JOSEPH C. DOTCHVILLE SUBDIVISION

APPLICATION NUMBER 7 DATE March 15, 2012
APPLICANT Joseph C. Dortchville Subdivision
REQUEST Subdivision

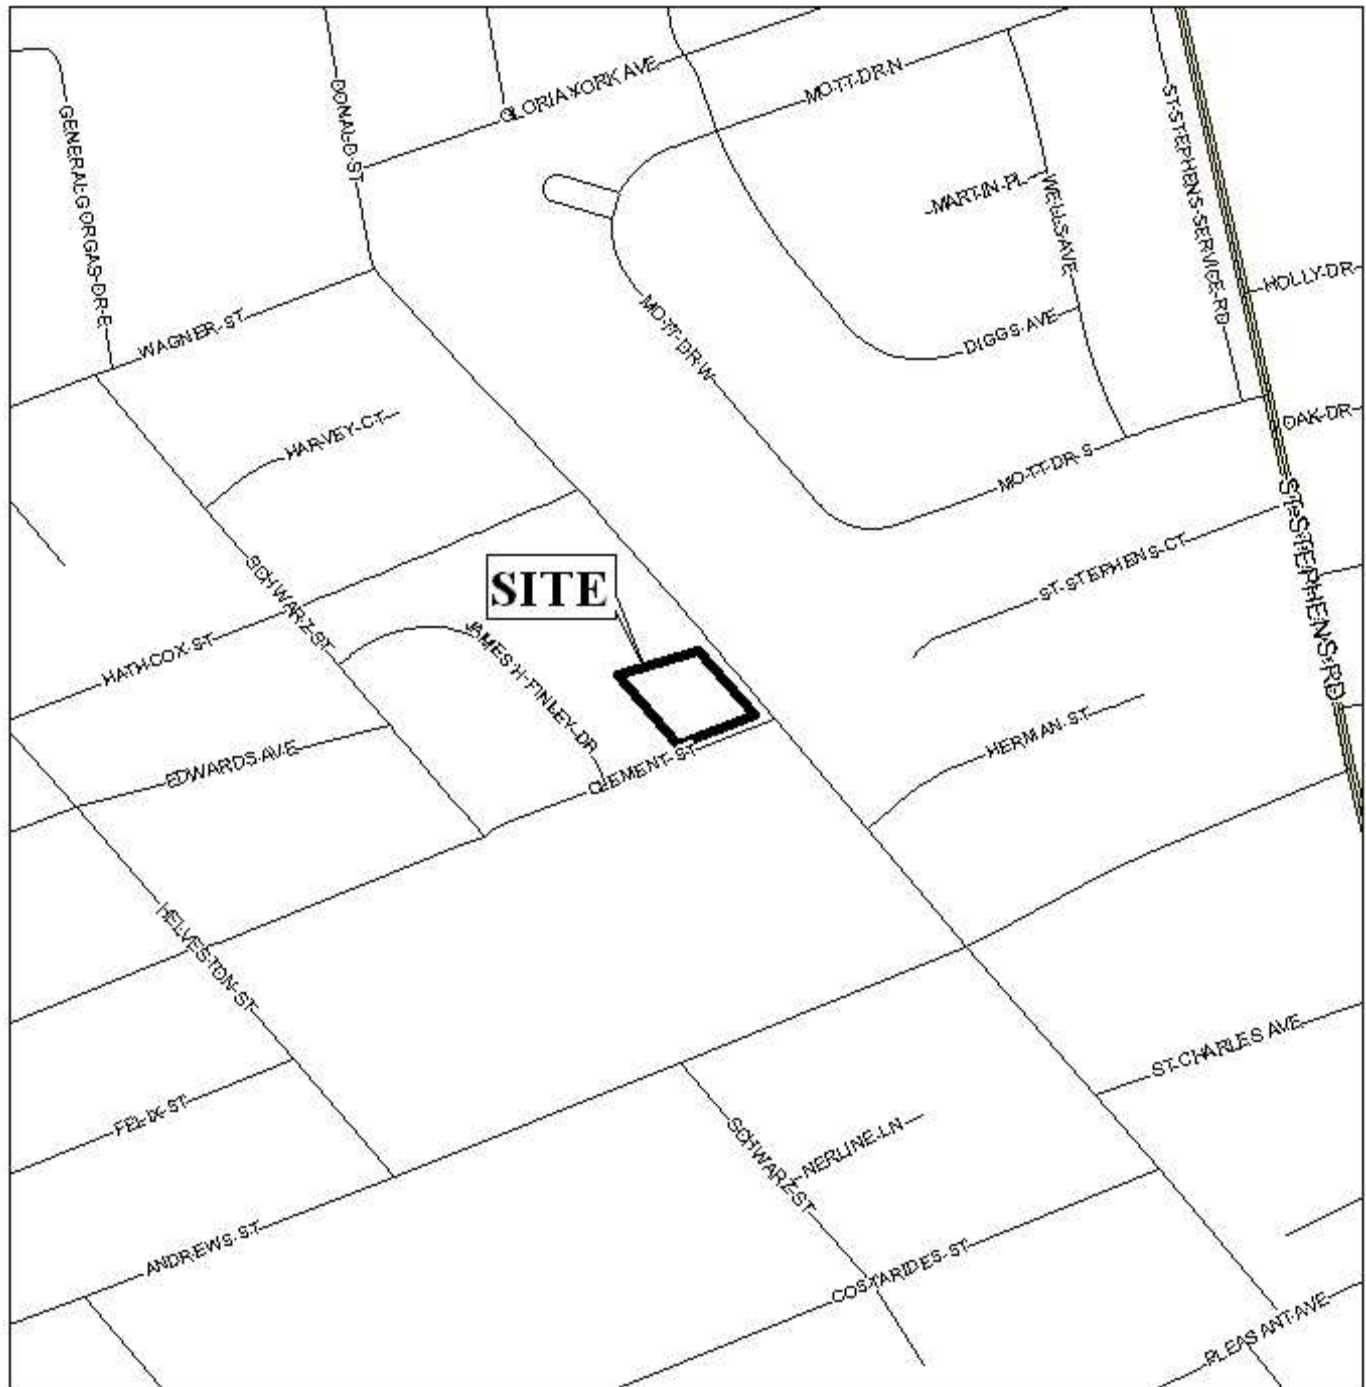
The plat illustrates the proposed 0.8± acre, 1-lot subdivision which is located on the Northwest corner of Donald Street and Clement Street, and is in Council District 1. The applicant states that the subdivision is served by both public water and sanitary sewer.

The purpose of this application is to create a legal lot of record from a single metes-and-bounds parcel. The lot size is labeled in square feet and acres, and the proposed lot would exceed the minimum size requirements of Section V.D.2. of the Subdivision Regulations. The lot size should be retained on the Final Plat, if approved.

The 25-foot minimum building setback line, required in Section V.D.9., is illustrated and labeled on the preliminary plat, and should be retained on the Final Plat, if approved.

The site fronts Donald Street and Clement Street, both minor streets that have curb and gutter. Donald Street is illustrated as having a varying right-of-way, whereas Clement Street is illustrated as having a 40' right-of-way. As minor streets provided with curb and gutter, both streets should have a right-of-way of 50'. Therefore, dedications should be made to provide 25' from the centerline of both Donald Street and Clement Street. Furthermore, dedication of the corner radii at Donald Street and Clement Street per Section V.D.6. of the Subdivision Regulations should be required.

As a means of access management, a note should be placed on the Final Plat, if approved, stating that the development is limited to the existing curb cut to Clement Street, with the size, location and design to be approved by Traffic Engineering and conform to AASHTO standards.

- 1) dedication to provide 25' from the centerline of Donald Street to the City of Mobile;
- 2) dedication to provide 25' from the centerline of Clement Street to the City of Mobile;

- 3) dedication of the corner radii at Donald Street and Clement Street per Section V.D.6. of the Subdivision Regulations should be required;
- 4) retention of the 25-foot minimum building setback line along all right-of-way frontages;

- 5) retention of the labeling of the lot with its size in square feet and acres, or placement of a table on the plat with the same information;
- 6) compliance with Engineering comments (*A 4' wide sidewalk shall be installed along Donald Street and Clement Street along the entire property frontage. A handicapped ramp shall be installed at the corner. Any work performed in the existing ROW (right-of-way) such as driveways, sidewalks, utility connections, drainage, irrigation, or landscaping will require a ROW permit from the City of Mobile Engineering Department (208-6070) and must comply with the City of Mobile ROW code and ordinances. If the proposed improvements increase the total impervious area of the site to over 4,000 square feet the owner will be required to provide on-site detention, which must comply with all storm water and flood control ordinances of the City of Mobile.*);

- 8) placement of a note on the Final Plat limiting the development to the existing curb cut to Clement Street, with the size, design, and location to be approved by Traffic Engineering and conform to AASHTO standards; and
